SECTION 009111.13 - ADDENDUM NUMBER 3

- 1.1 **DATE: DECEMBER 17 2024**
- 1.2 **PROJECT: FULTON CO. PUBLIC LIBRARY: ADDITION, RENOVATIONS & SITE IMPROVEMENTS TO: AUBBEE, FULTON & ROCHESTER LIBRARIES**
- 1.3 **PROJECT NUMBER: 24029**
- 1.4 **OWNER: FULTON COUNTY PUBLIC LIBRARY, 320 W. 7TH STREET, ROCHESTER, IN 46975**
- 1.5 **ARCHITECT: ODLE MCGUIRE SHOOK MATTHEW R. MAYOL #IN19900090**

- A. AUBBEE BRANCH: C2.0, C3.1, C7.0 AND C7.1
 - B. FULTON BRANCH: C1.0, C7.0, C7.1 AND L100
 - C. ROCHESTER LIBRARY: C0.0, C1.0, C2.0, C3.0, C3.1, C7.0, DA102, A102, A103, A105, A401, A202, A203, A501.

EXISTING CONDITIONS/DEMOLITION PLAN

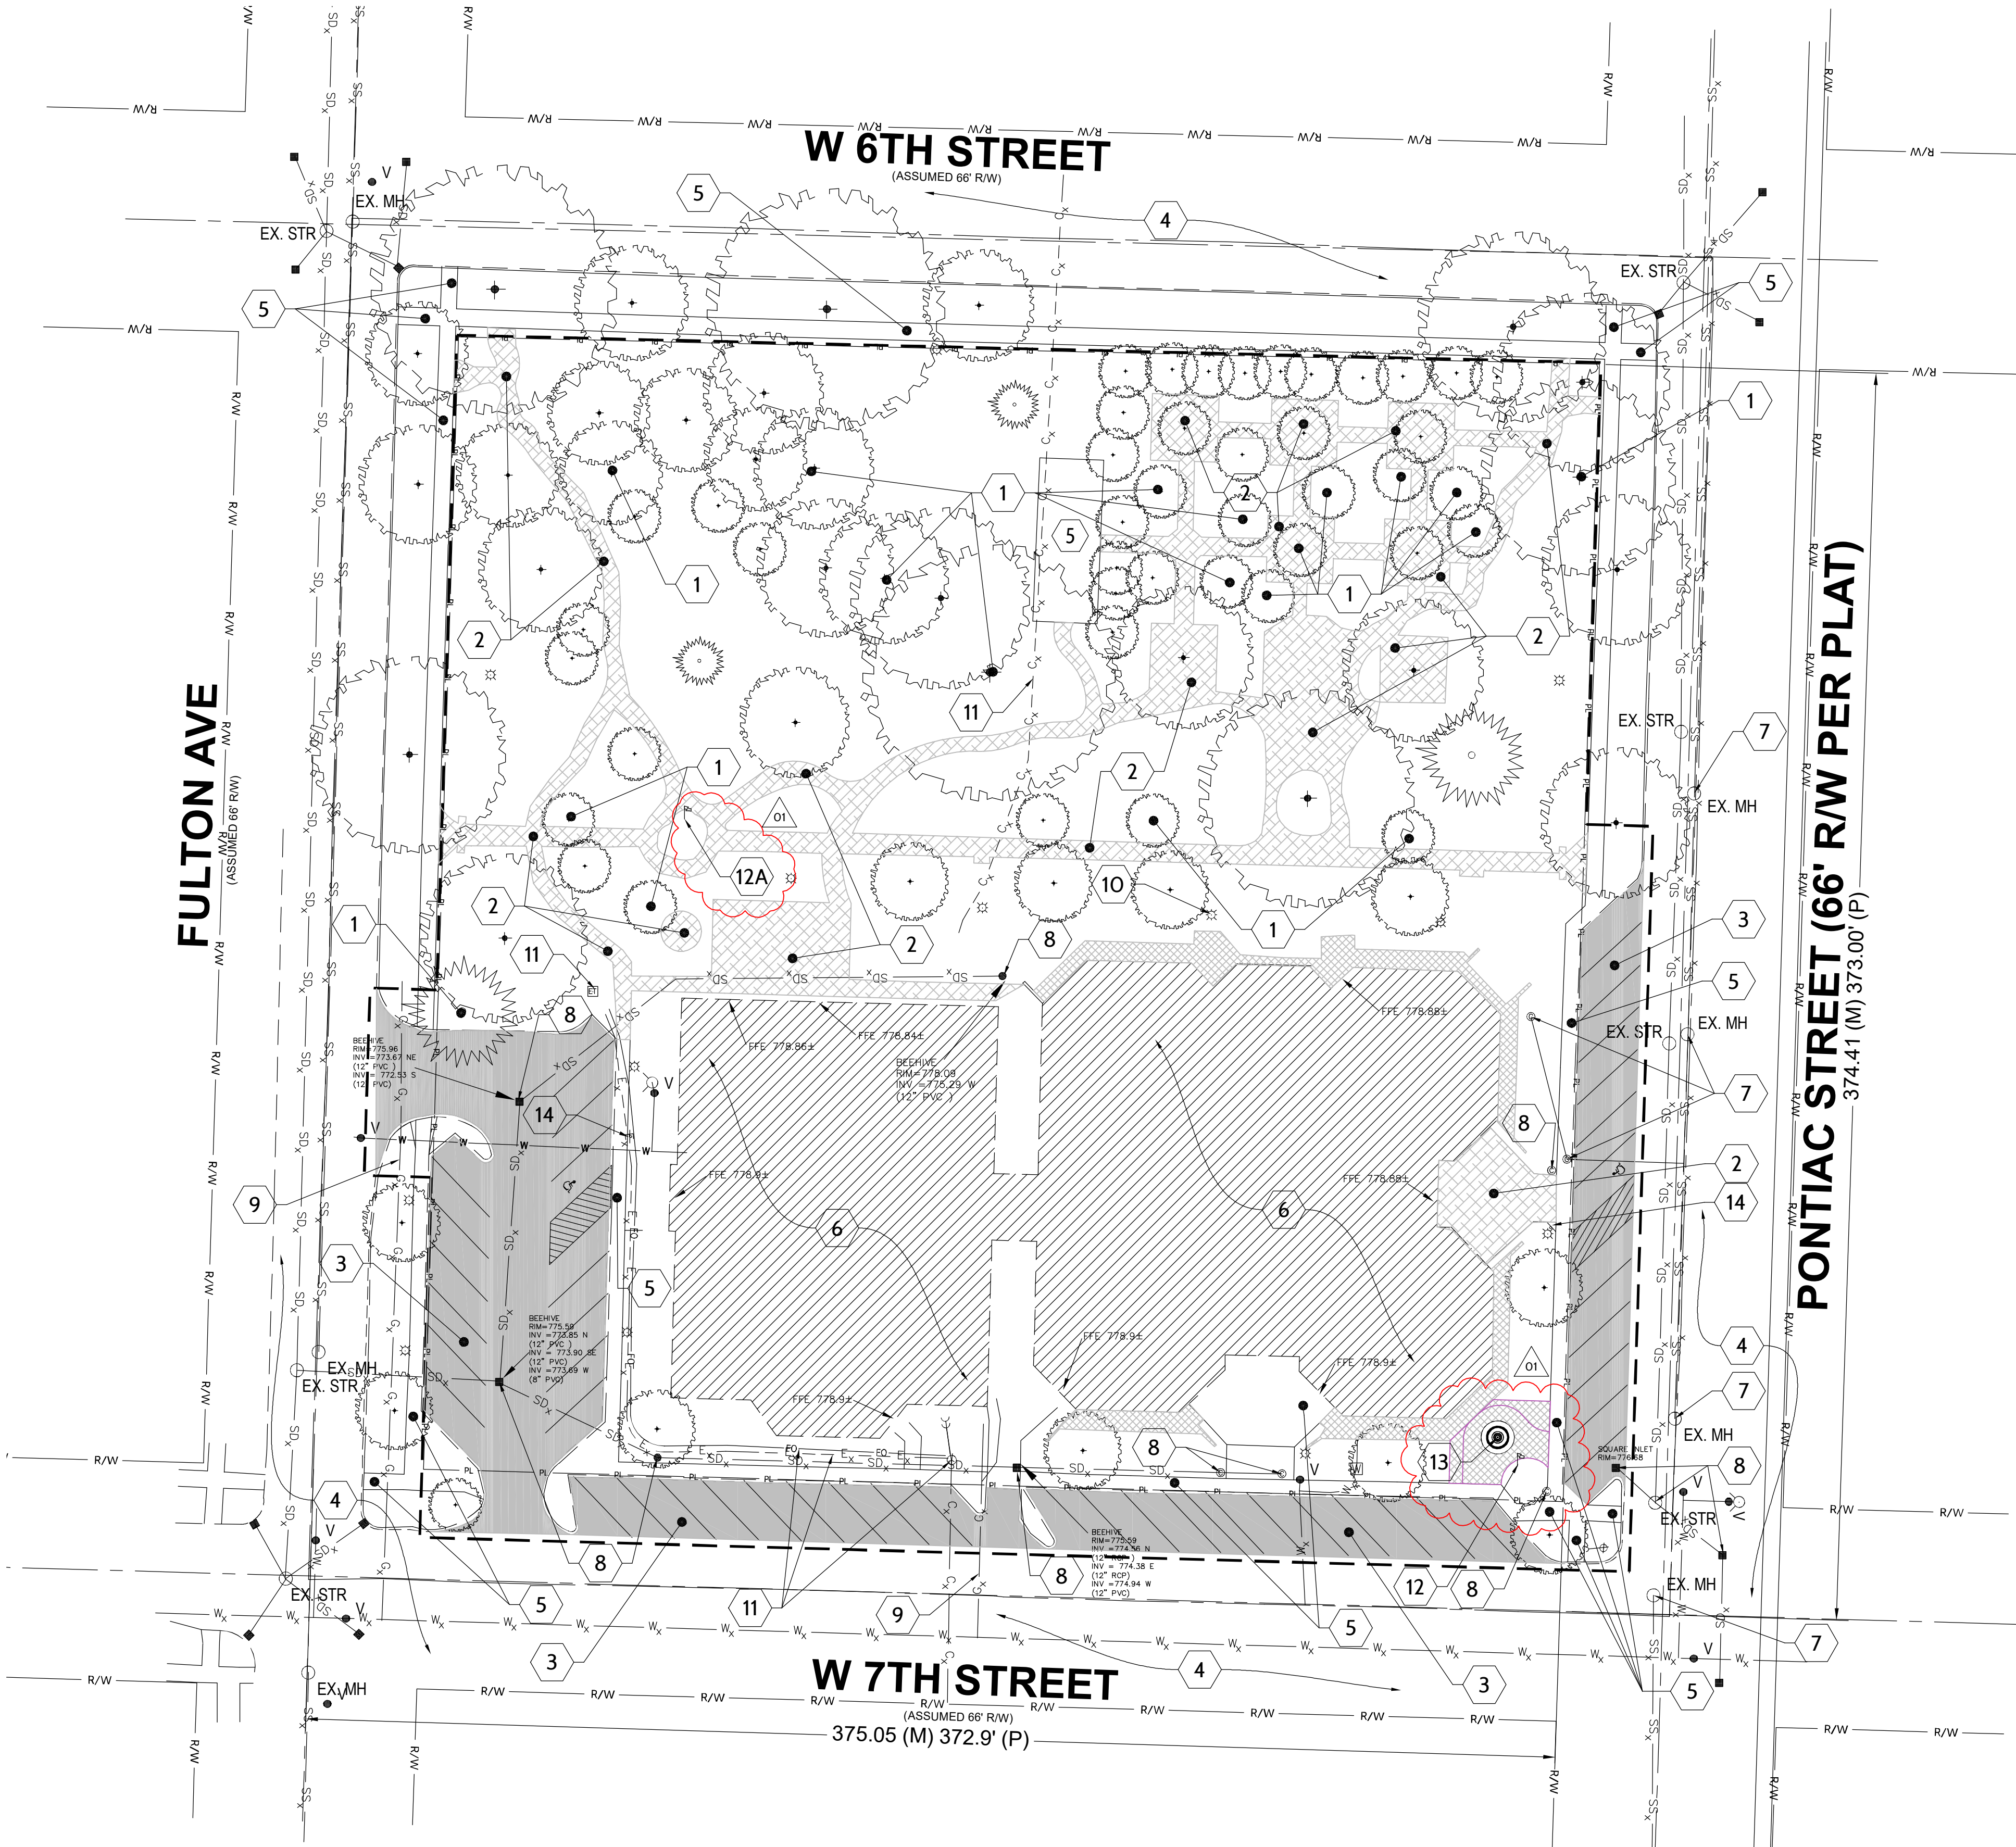
3. Q: (Fulton) Can we get some clarification as to what concrete sidewalk we're to remove on the northside of the existing building? Looking at the google earth images it appears there is concrete sidewalk all along the north side of the building. Are we to remove all of it or only where the call out numbers are?

- a. A: Please see the revised sheet C1.0 with callouts specifically addressing that section of abandoned sidewalk, as well as the callout to specify the location of the existing landscape bed that needs to be removed.

DA102
 AREA A DEMO PLAN

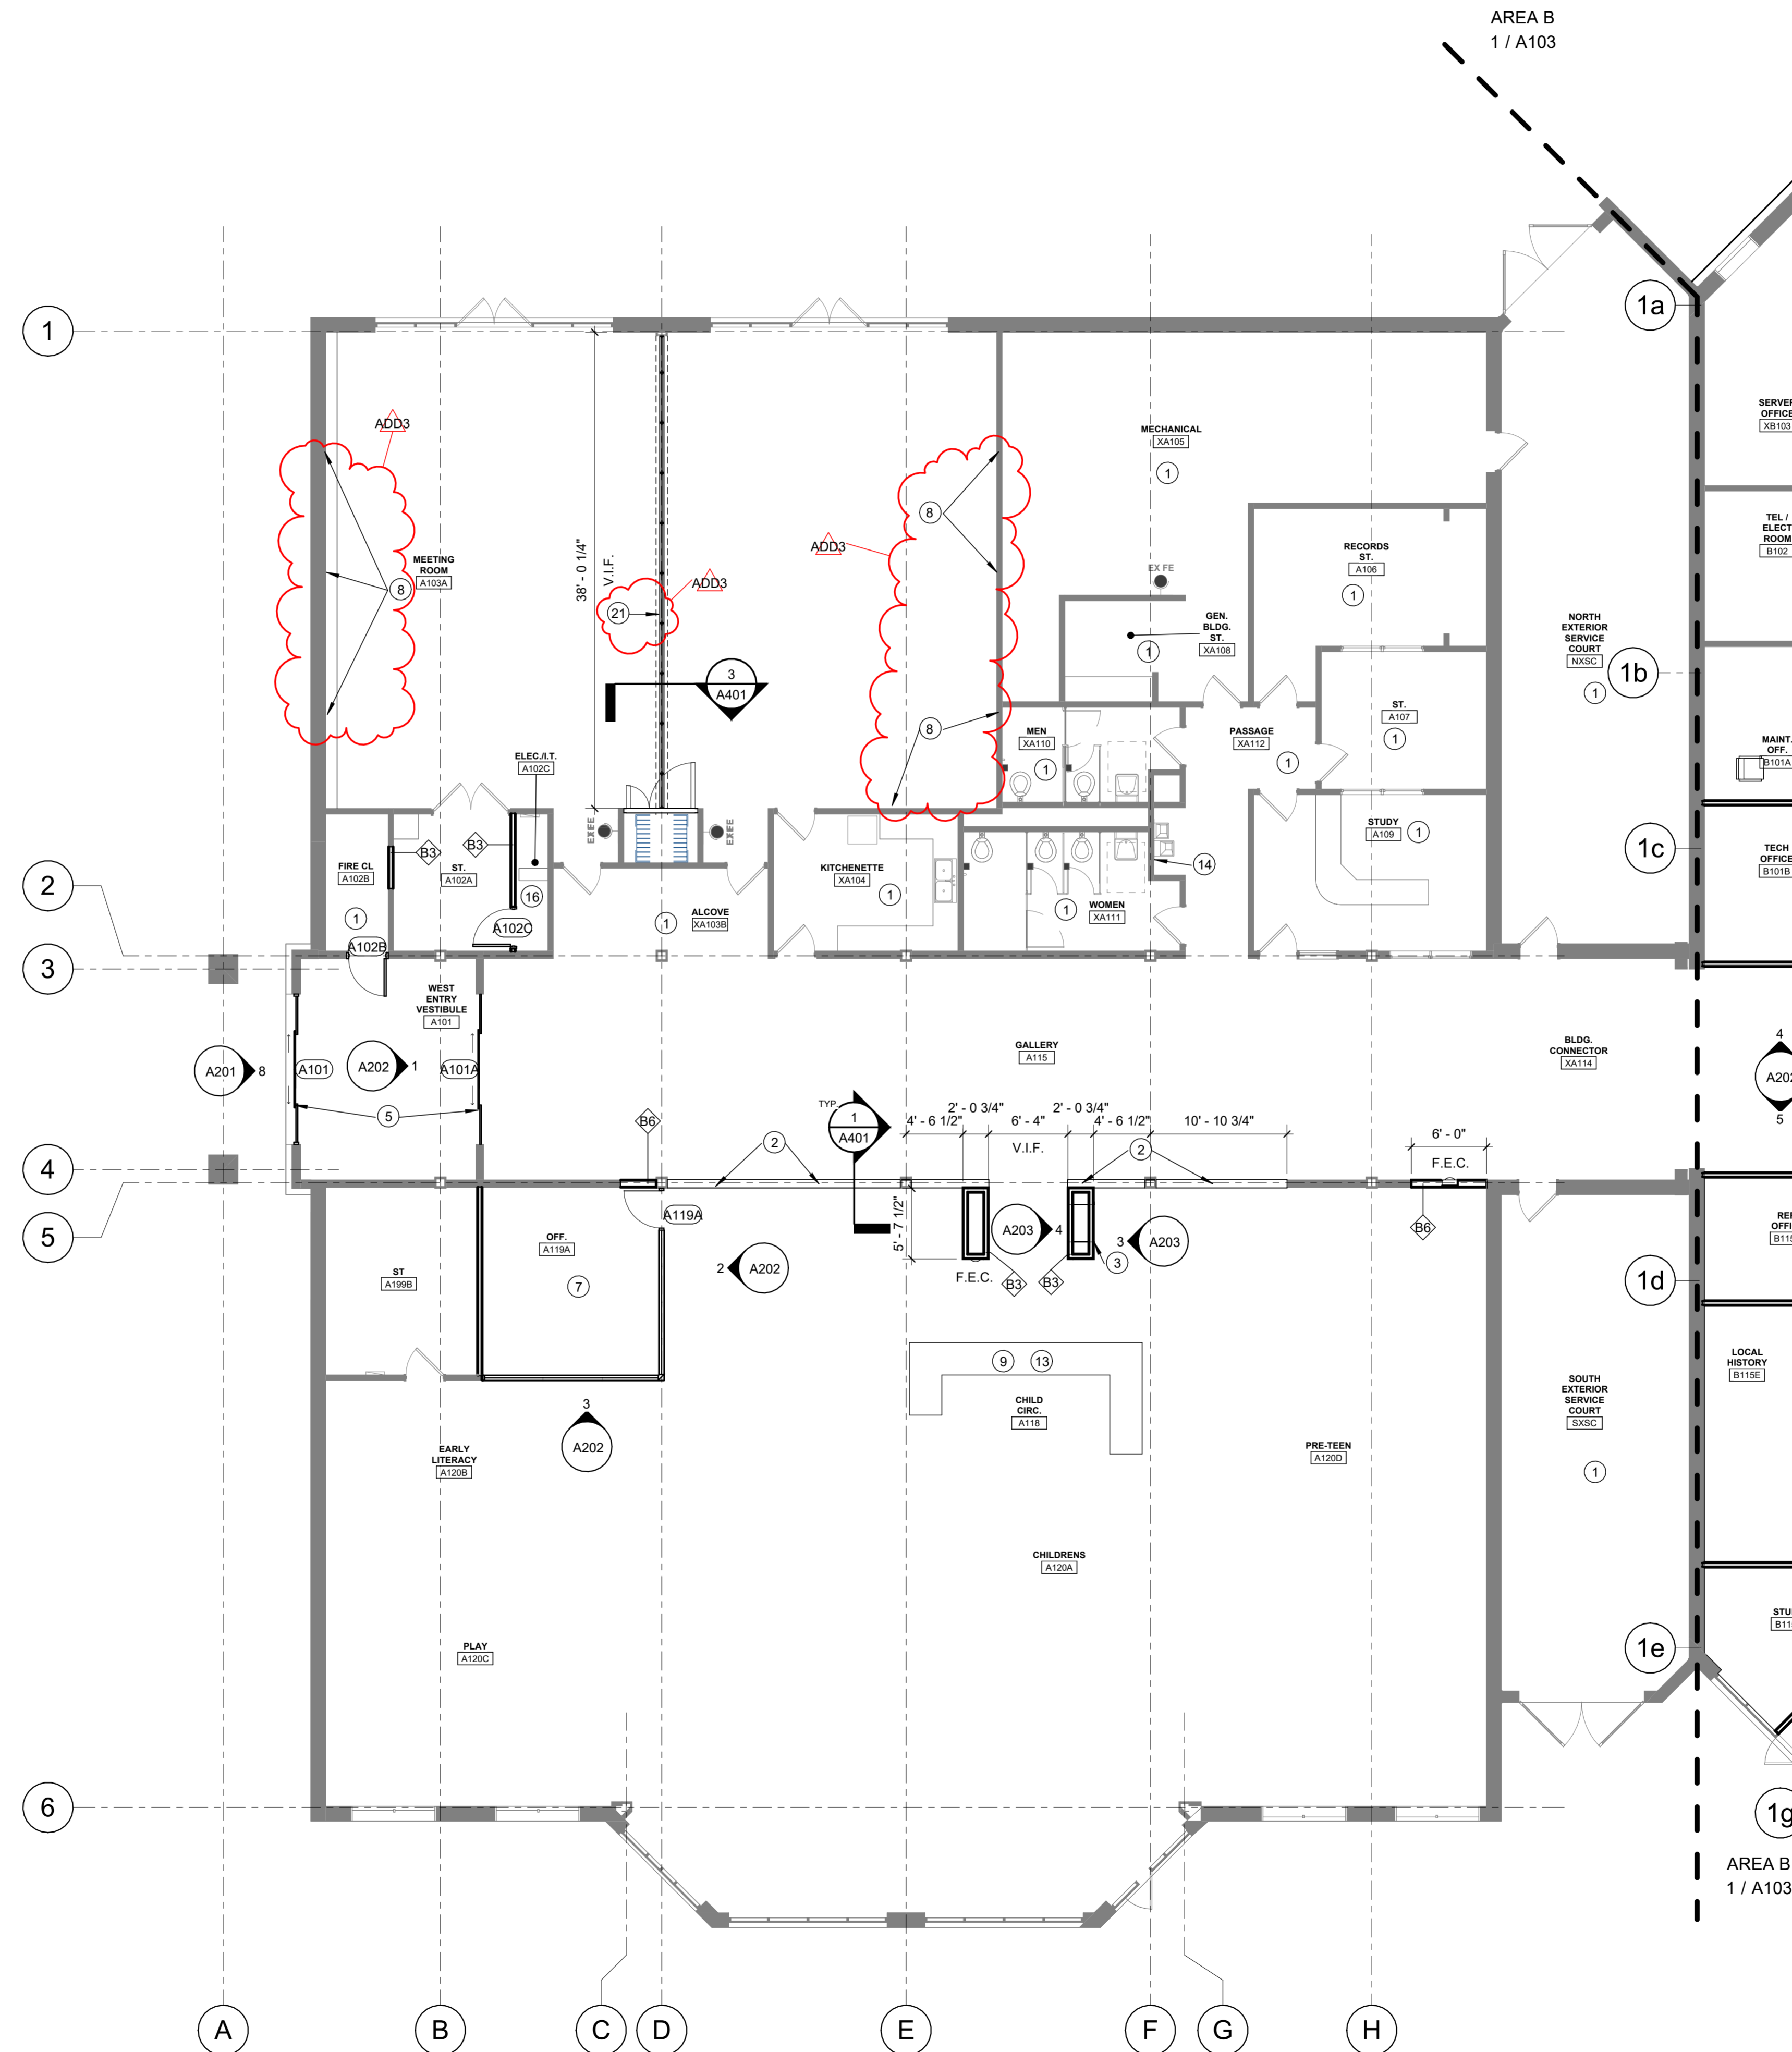
- A. Refer to Revision Triangles.
1. DA102 – Remove plan note 4 in rooms XA116, XA117, XA118, XA119, & XA120
 2. A102 – revise plan note 19 to plan note 21, to read "NEW ELECTRICALLY OPERATED FOLDING PANEL PARTITION"
 3. A103, A203 – Revise plan note 8 to read "THREE (3) WALL-MOUNTED ACOUSTICAL PANELS, BASIS OF DESIGN KIREI 'DUNE' PANELS, COLOR TO BE SELECTED BY ARCHITECT. ARRANGE ON WALLS INDICATED SIMILAR TO DETAIL 7/A203"
 4. A105 – Delete plan note 5.
 5. A401 – Revise detail 2 to include note reading "CONTRACTOR'S OPTION TO PROVIDE A Poured CONCRETE STRIP FOOTER TO SUPPORT THE NEW MASONRY VENEER. ASSUME APPROXIMATELY 16 INCHES WIDE WITH A DEPTH DOWN TO THE TOP OF EXST. FOOTER."
